RE: *Initial Submission Review – Economy Rental Parking Expansion - Site Plan Amendment and Plat*
Application Number: DA-2113-01
Case Numbers: 2017-6049-02; 2023-3018-00

ECONOMY RENTAL PARKING EXPANSION
 AT PORTEOS - PARCEL B
 SITE PLAN
 CITY OF AURORA
 OVERALL SITE PLAN

ECONOMY RENTAL PARKING EXPANSION AT PORTEOS SUBDIVISION FILING NO. 2

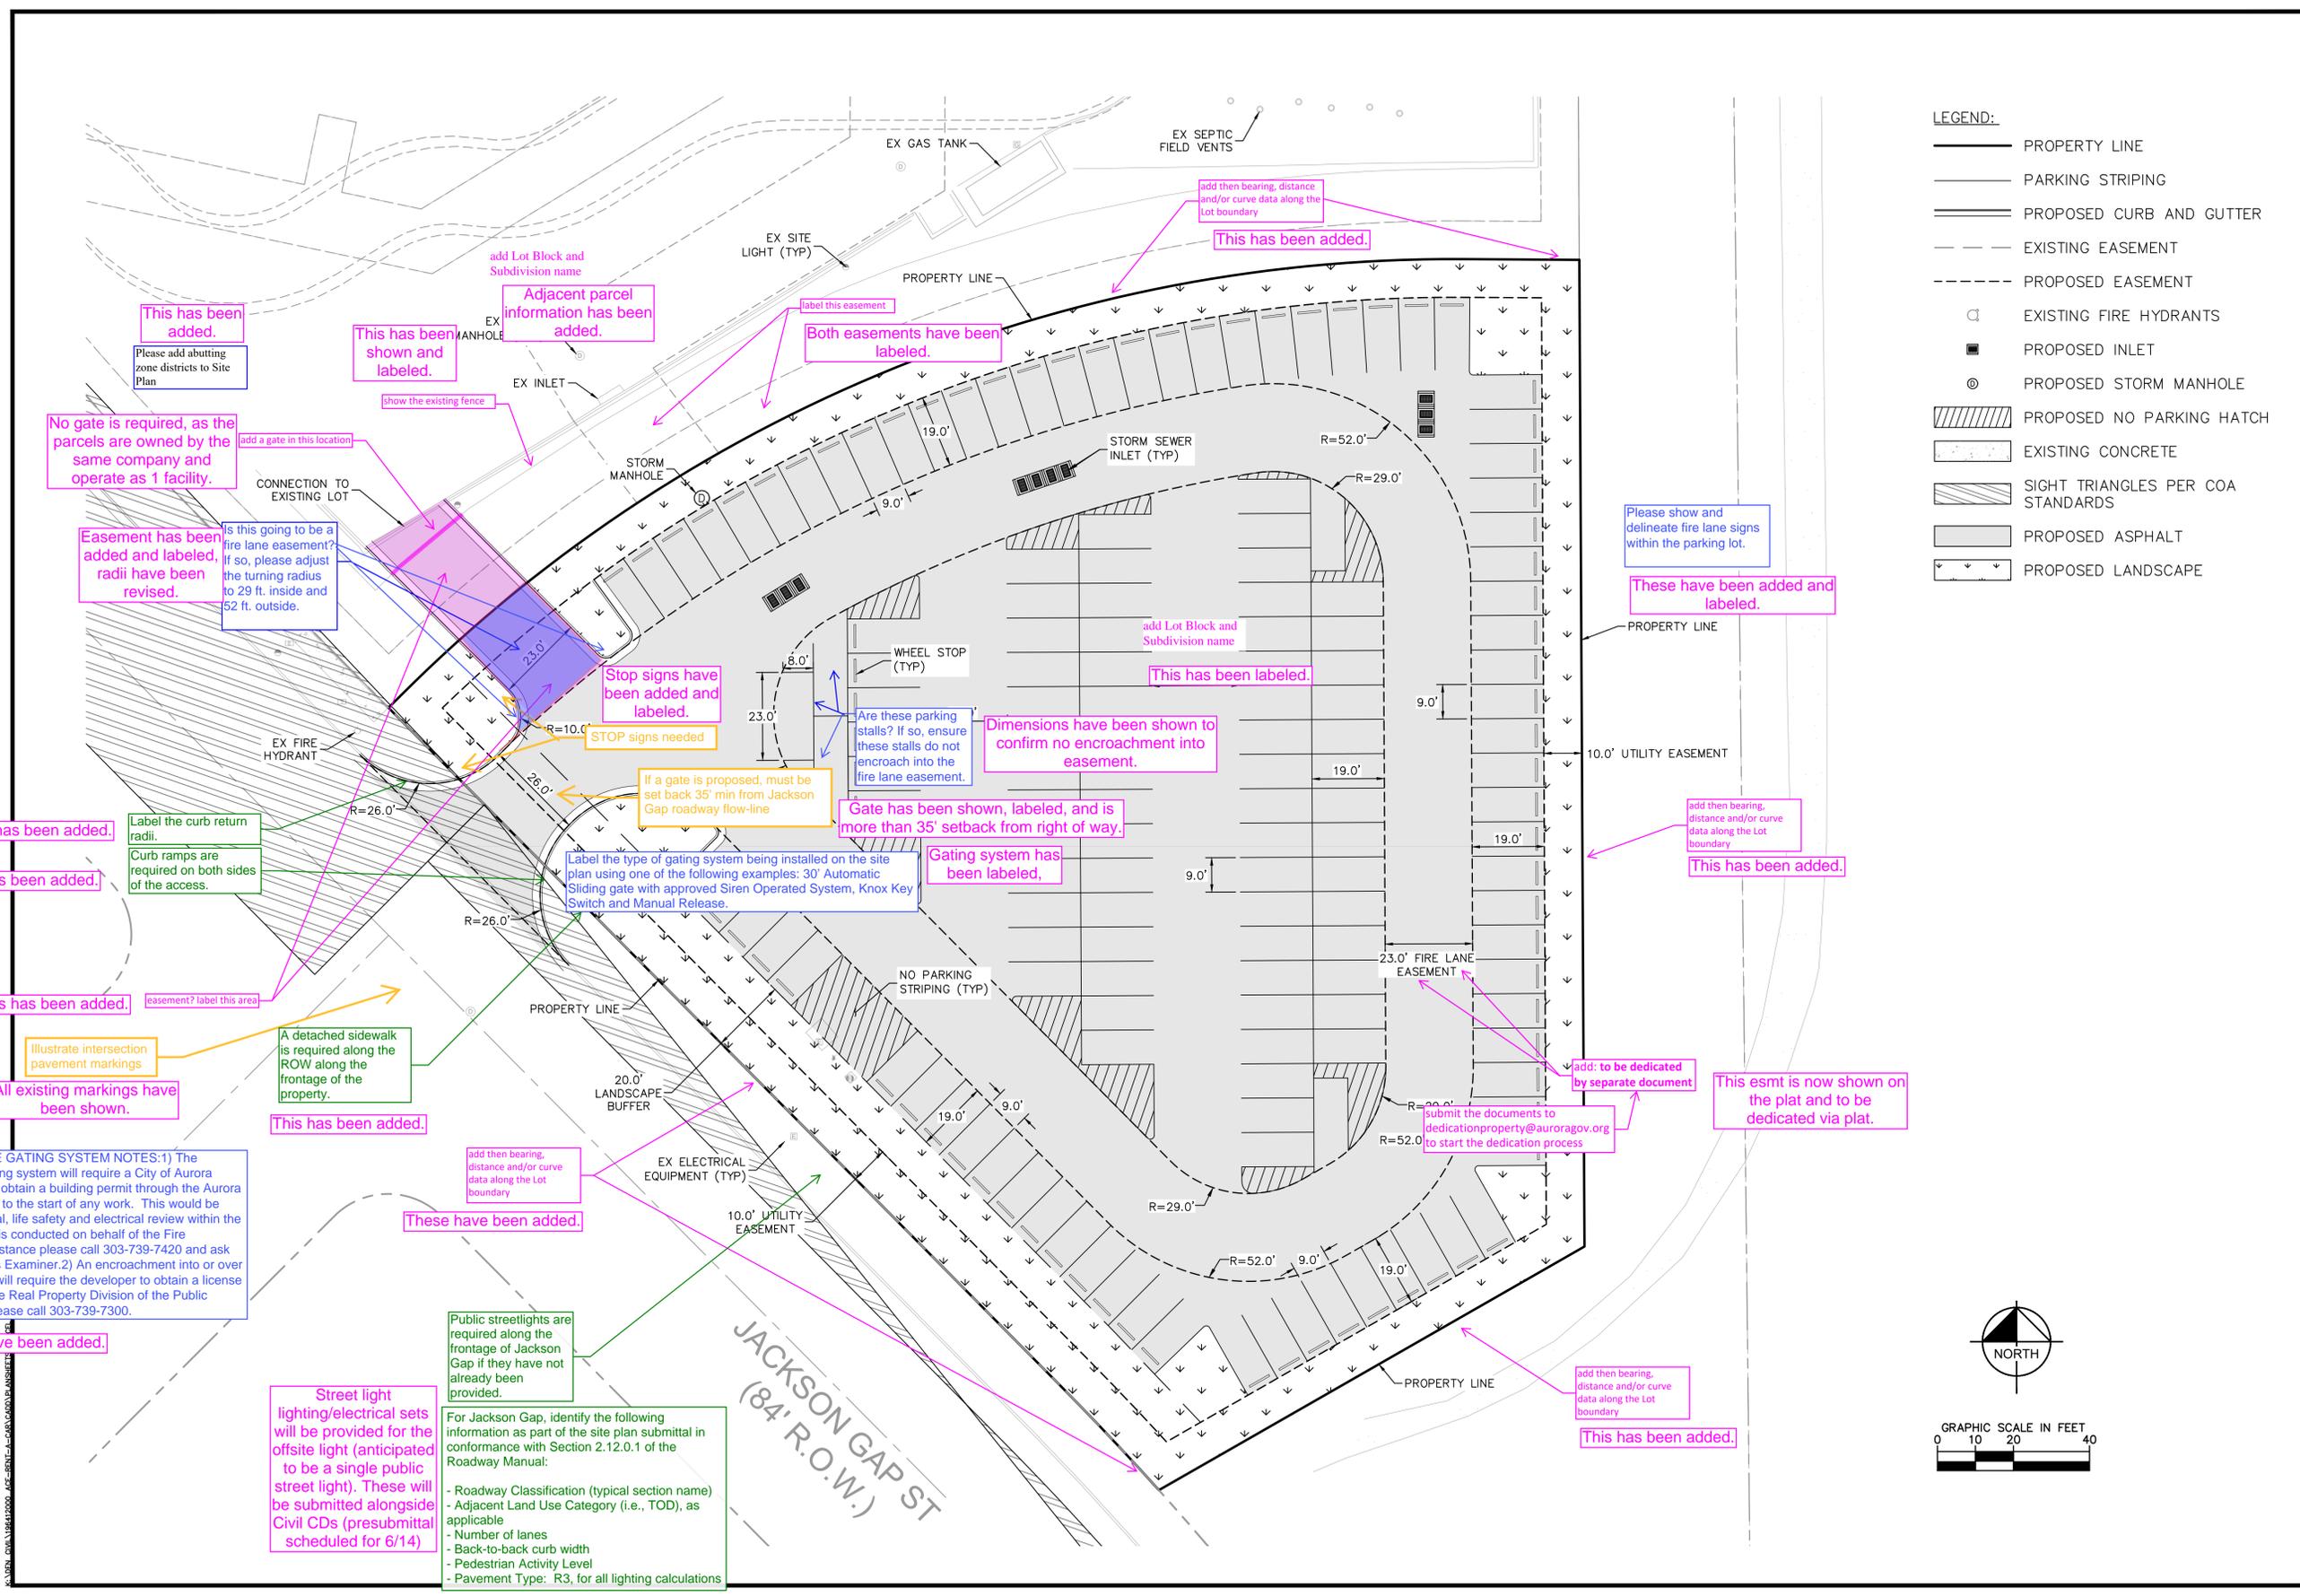
Public streetlights are required along the frontage of Jackson Gap if they have not already been provided.

A detached sidewalk is required along the ROW along the frontage of the property.

Curb ramps are required on both sides of the access.

Label the curb return radii.

Label the type of gating system being installed on the site plan using one of the following examples: 30' Automatic Sliding gate with approved Siren Operated System, Knox Key Switch and Manual Release.

If a gate is proposed, must be set back 35' min from Jackson Gap roadway flow-line

STOP signs needed

Are these parking stalls? If so, ensure these stalls do not encroach into the fire lane easement.

label this easement

add a gate in this location

Please add abutting zone districts to Site Plan

add then bearing, distance and/or curve data along the Lot boundary

Please show and delineate fire lane signs within the parking lot.

Street light lighting/electrical sets will be provided for the offsite light (anticipated to be a single public street light). These will be submitted alongside Civil CDs (presubmittal scheduled for 6/14)

STOP signs have been added and labeled.

Dimensions have been shown to confirm no encroachment into easement.

Both easements have been labeled.

Adjacent parcel information has been added.

No gate is required, as the parcels are owned by the same company and operate as 1 facility.

Easement has been added and labeled, radii have been revised.

This has been added.

These have been added and labeled.

**ECONOMY RENTAL PARKING EXPANSION
 AT PORTEOS - PARCEL B
 SITE PLAN
 CITY OF AURORA
 DETAILED GRADING PLAN**

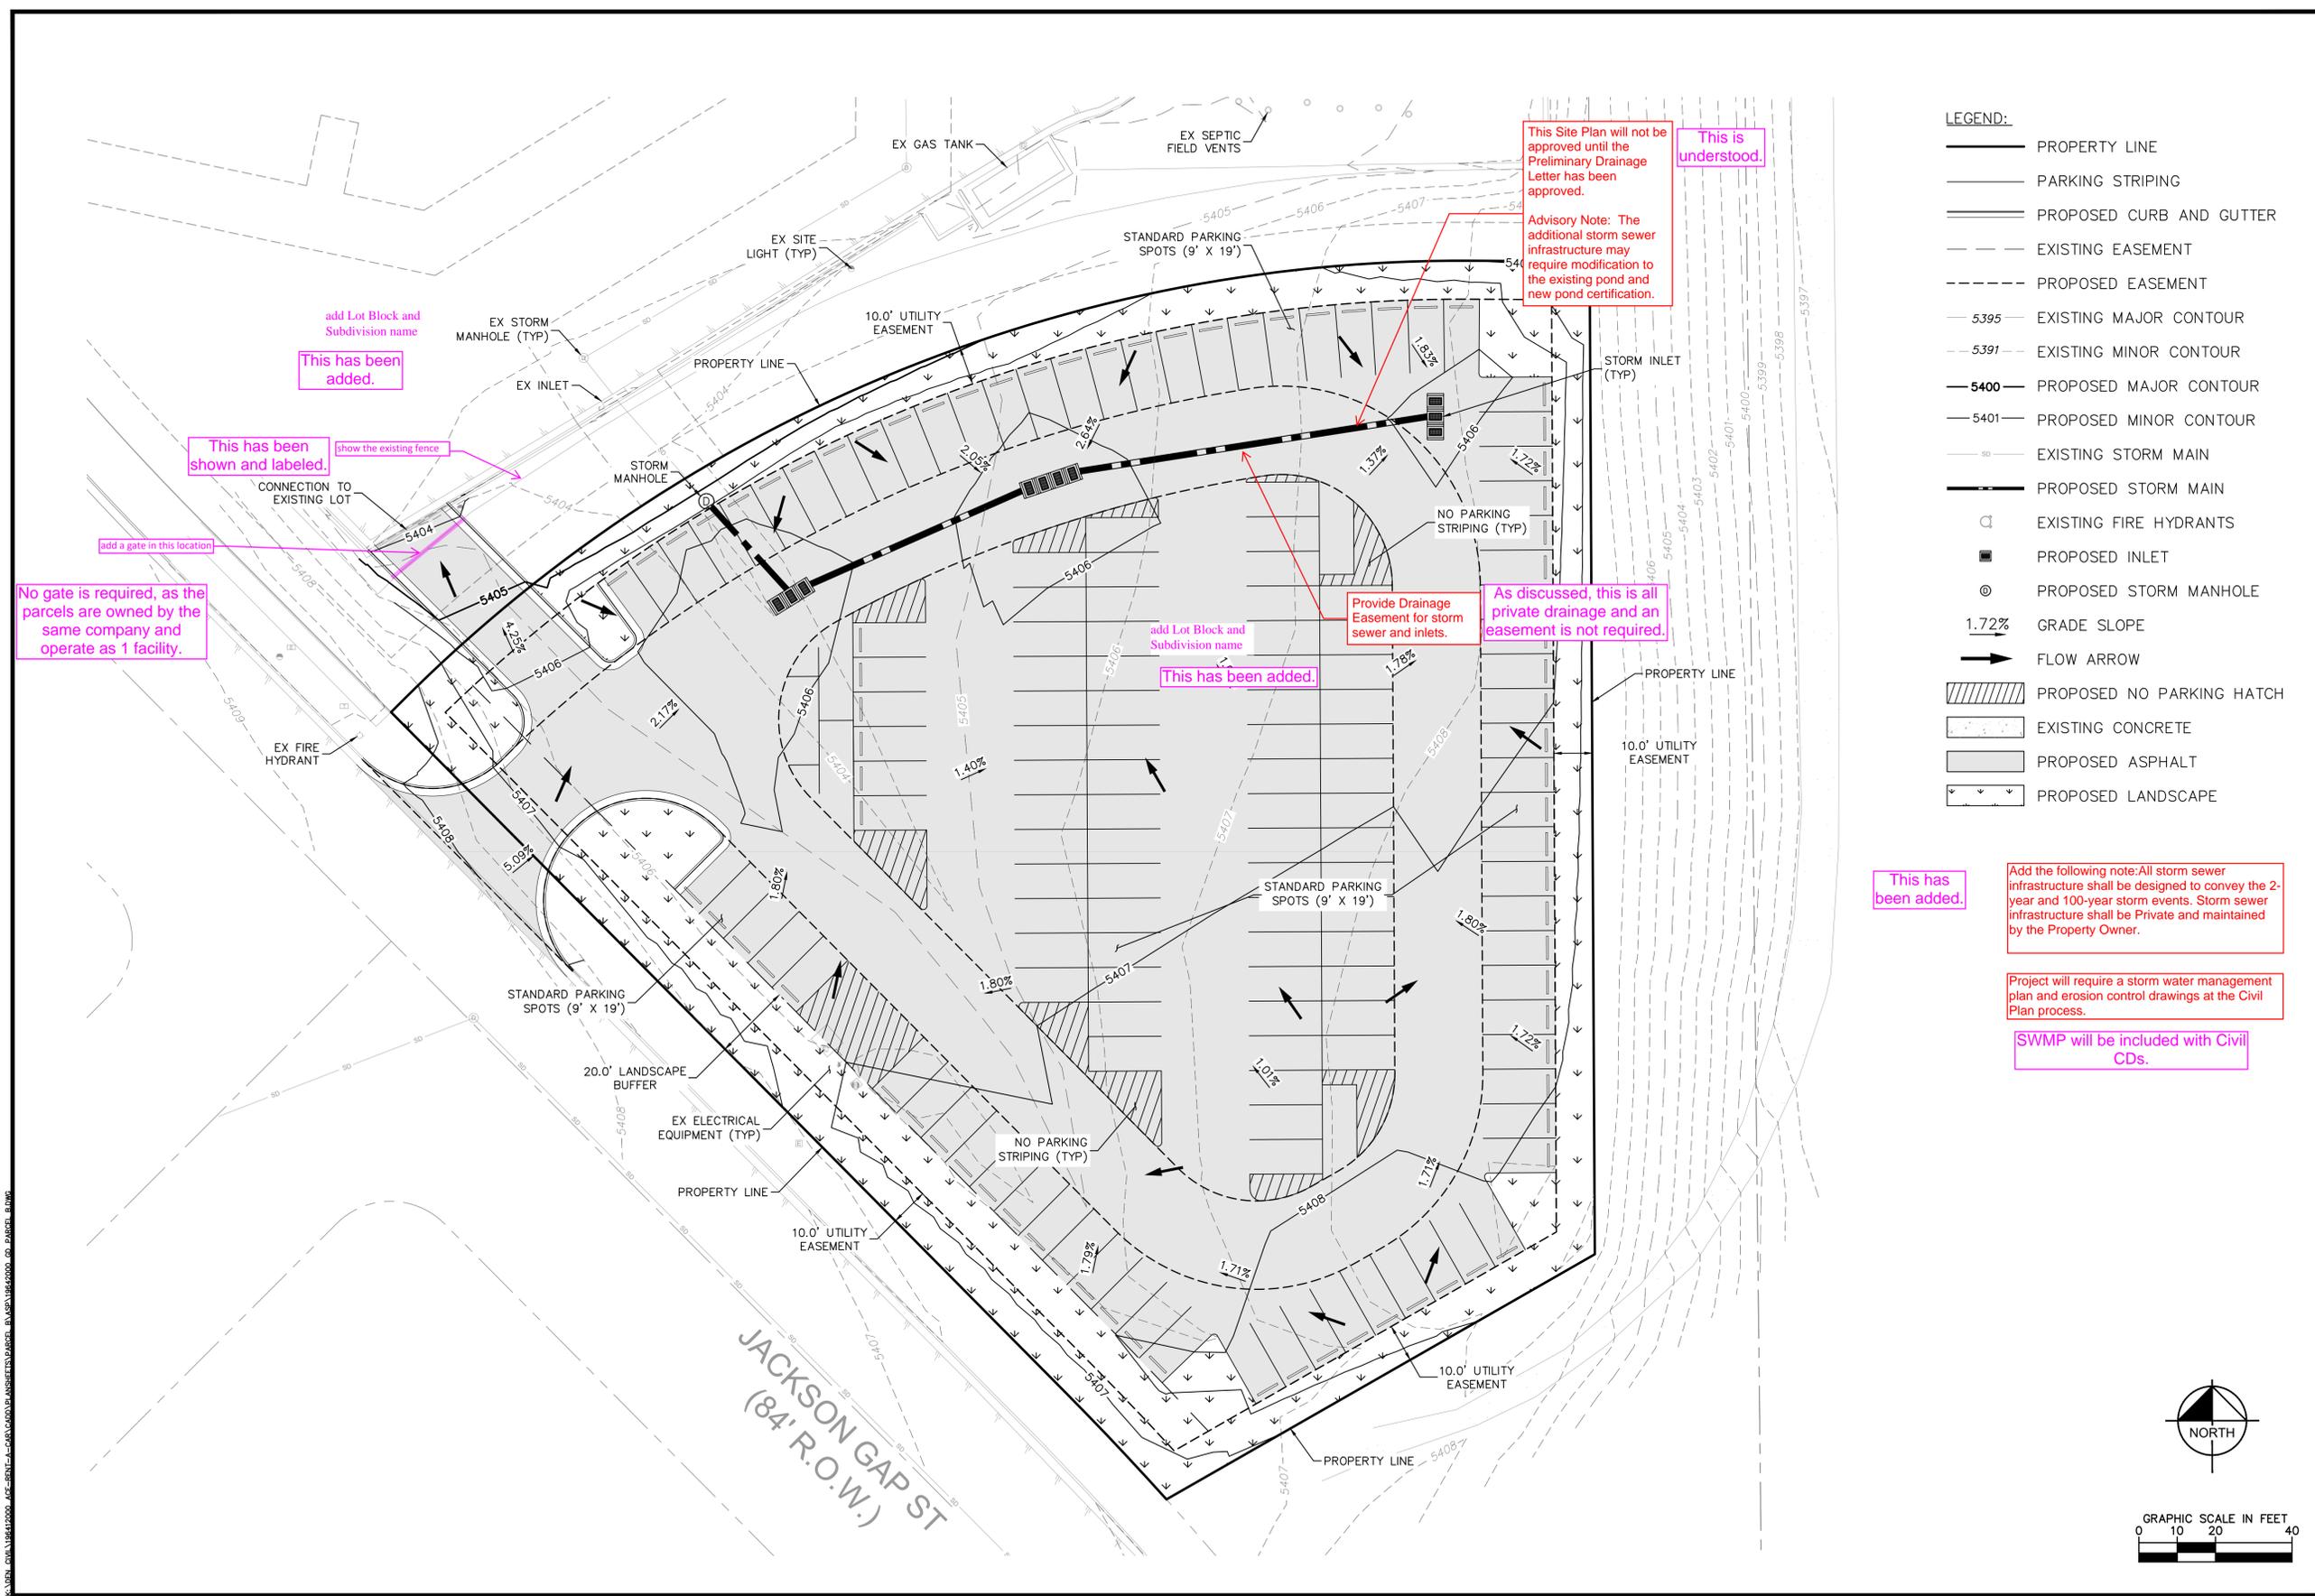
add: to be dedicated by separate document

submit the documents to dedicationproperty@auroragov.org to start the dedication process

add then bearing, distance and/or curve data along the Lot boundary

This esmt is now shown on the plat and to be dedicated via plat.

This has been added.
